Z-78
(2014)

FINAL PLAT FOR
HEATHERMOOR
SUBDIVISION

PETITION NO: Z-78
HEARING DATE (PC): 11-04-14
HEARING DATE (BOC): 11-18-14
PRESENT ZONING: R-20
With Stipulations
PROPOSED ZONING: R-20
With Stipulations
PROPOSED USE: Reduce Cemetery Buffer
on Six Lots
SIZE OF TRACT: 3.0 acres
DISTRICT: 1
LAND LOT(S): 134, 166
PARCEL(S): 55, 56, 57, 65, 66, 67
TAXES: PAID X **DUE** _____
COMMISSION DISTRICT: 3

ZONING COMMENTS:

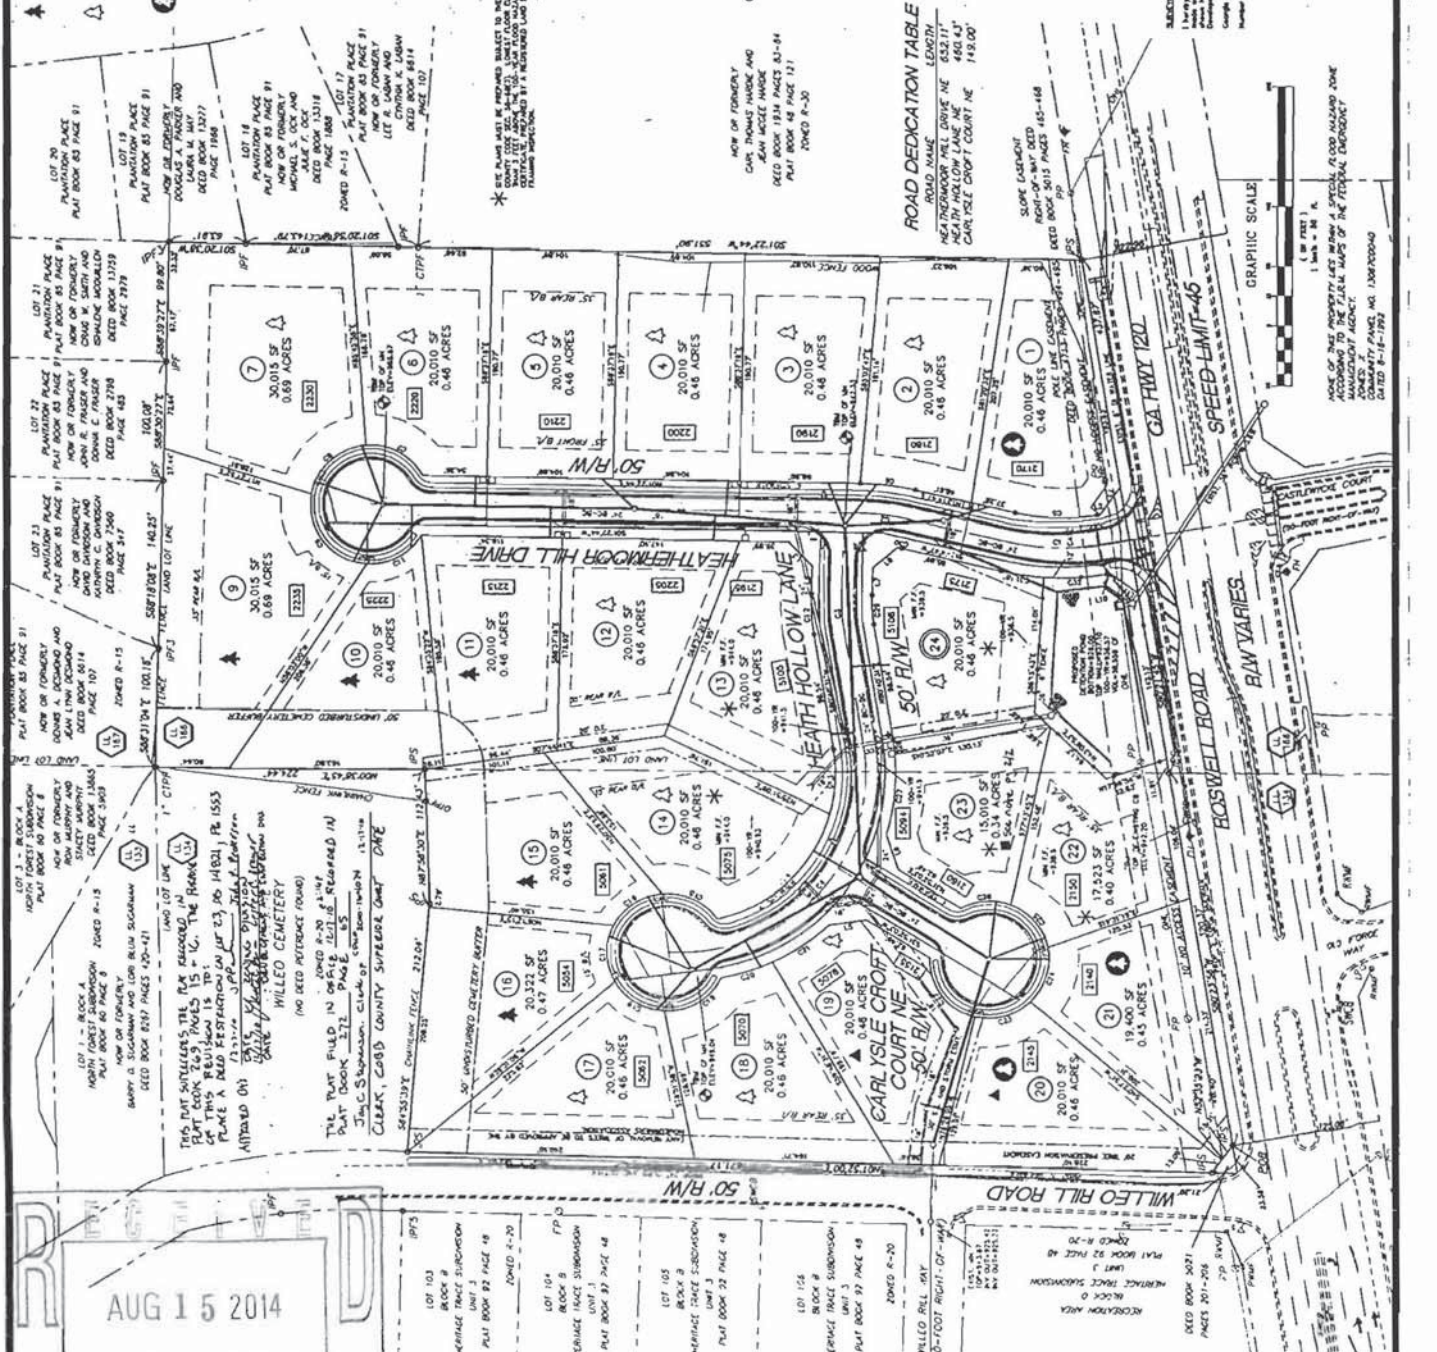
The applicant is requesting a rezoning to allow the reduction of the previously stipulated 50 foot cemetery buffer that lies along the subdivision's northwest corner adjacent to Willeo Cemetery affecting six (6) of the 23 lots within the subdivision. The applicant cites the "required size of the homes that the neighborhood standards demand" as well as "the sight of a cemetery headstone" as reasons that the cemetery buffer should be reduced to a "landscaped greenspace" with a fence running along the lots' rear property lines approximately halfway within the 50 foot buffer. There have been, in the past, a variance approved within this subdivision regarding overbuilt lots and impervious restrictions that were put into place in relation to the size of homes being built. Also, the cemetery was present and its Code required buffer was approved at the time of the property's original rezoning.

Immediately preceding the filing of the current application, Code Enforcement had responded to the clearing of the replanted buffer by a homeowner adjacent to the Cemetery. On this particular lot, the buffer was partially cleared by the original builder and its replanting was required before the County would issue the Certificate of Occupancy to the second, most recent builder. It was this replanted buffer which was moved by the subsequent homeowner to accommodate a sodded lawn and retaining wall 35 feet into the buffer.

The buffer is clearly shown on the final plat of the subdivision that all homeowners receive. The Wileo Baptist cemetery predates the Heathermoor subdivision by over 100 years and the development standards are in place to ensure that the cemetery remains protected for another 100 years.
